## 1 INTRODUCTION AND BACKGROUND TO REPORT

This document provides a response to the Third Party Submissions made by various parties on the response Jennings O'Donovan submitted (the Submissions Response Document) in response to the submissions received on the Strategic Infrastructure Development Application Reference ABP-317560-23 made to An Bord Pleanála by Mercury Renewables (Carrowleagh) Limited, for the construction of a wind farm and hydrogen plant and related works. This document addresses the submissions received individually. The responses on behalf of the Applicant are in blue while submission text is in black.

Proposed windfarm development including 13 no. wind turbines in Bunnyconnellan, Co. Mayo and hydrogen plant in Castleconnor, Co. Sligo.

Figure 3: Hydrogen Plant elevations showing re-profiled landscape immediately adjacent

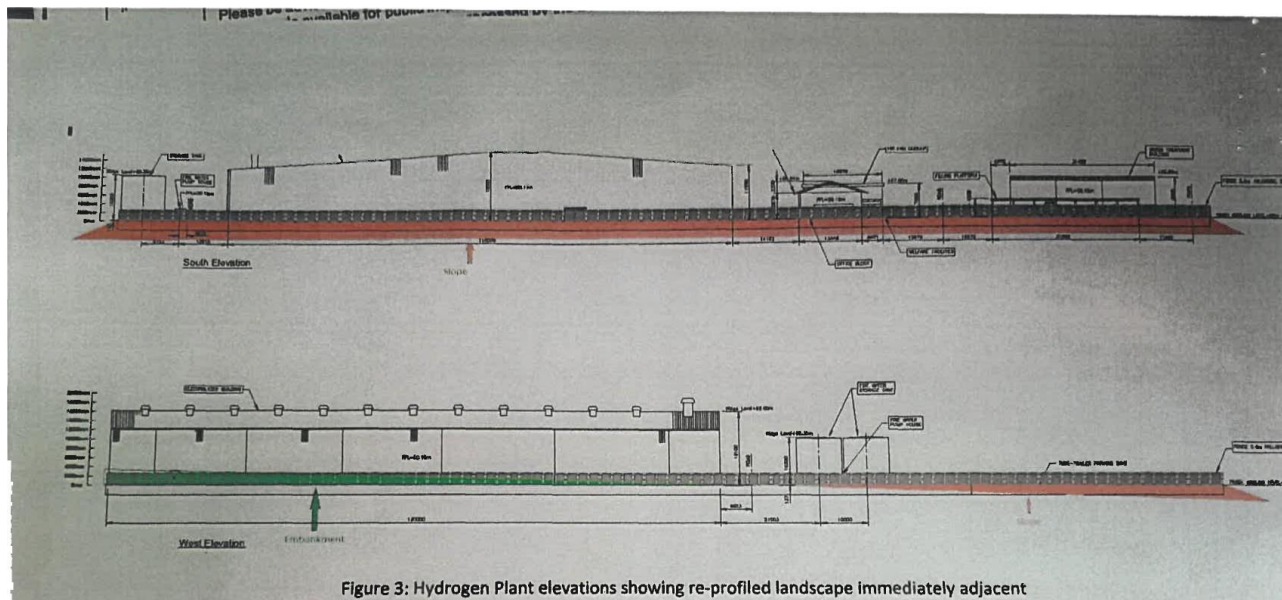
15.1 Chapter 11 paragraph 11.27.42 states: "The noise model accounts for the topography of the existing and proposed land in the vicinity of the site, where it is proposed that the Proposed Development will sit at a lower ground level in comparison to the existing land, where the raised land surrounding the site effectively acts as a barrier. "This is clearly untrue. Drawing 41035-1000- G1000 shows that the site has to be re-profiled, and that the whole of the south elevation is located on a 5m high slope. On the west elevation. The electrolyser plant has a low embankment in front of it, ranging from 3m at its highest point to ground level at the other end of the electrolyser building.

From there, a gradual slope descends some 5m below the plant's finished ground level. 15.2 A rough sketch is shown in Figure 3 below. This is not to scale. 15.3 Compared to the height of the electrolyser building, the low embankment (shown in green) will provide little noise attenuation, whereas the 5m slope (shown in brown) will only exacerbate the noise issue particularly to the south. 15.4 Chapter 11 Table 11.26 provides the output sound power level for site components and Figure 11.9 provides noise contours - presumably dBL Aeq,24h because the plant will run continuously).

15.5 Mitigation measures are set out in Chapter 11.27.4.4 but are lacking in detail — see paragraphs below.

15.6 The metal-clad Electrolyser building will be fitted with insulation that — according to the Applicant -has a 'minimum RW 3 of 35dB. However, this is a building some 130m long and 110m deep and 16m high that will contain equipment with an output noise level of 83dBA.

Given that it has doors, there are vents in the roof, and given that this is a metal clad-building with resonance potential, how can the Applicant be sure that 3SdB attenuation will be achieved?

15.7 The noise contour for the Electrolyser building is shown as 40dB yet with perfect insulation and no resonance, this figure should be  $83-35 = 48\text{dBA}$  !15.8

*Note the above figure was part of the submission from Theresa and Padraic Morrell.*

*The Planning Drawings submitted with the application include the correct finished floor levels. These were used to inform the technical assessments.*

*Response;*

*As per Table 11.23 of Chapter 11; Noise in the EIAR, – 83dB is an internal sound pressure level. The noise modelling assumes that 83 dB is the internal noise level which acts on all points of the internal building – this is a very conservative assessment. The sound insulation of the façade can be calculated, any vents or openings in the building are incorporated into the model as openings and considered in the predicted noise levels.*

*The internal sound pressure level is 83dB, the reduction from the façade is 35dB, this is relied upon to calculate the sound power level per square meter of the external building façade. This is the methodology relied upon in noise modelling.*

*The calculation as presented above in submission ( $83-35=48\text{dB(A)}$ ), would not be applicable to show the external noise level as presented by the noise contour levels.*
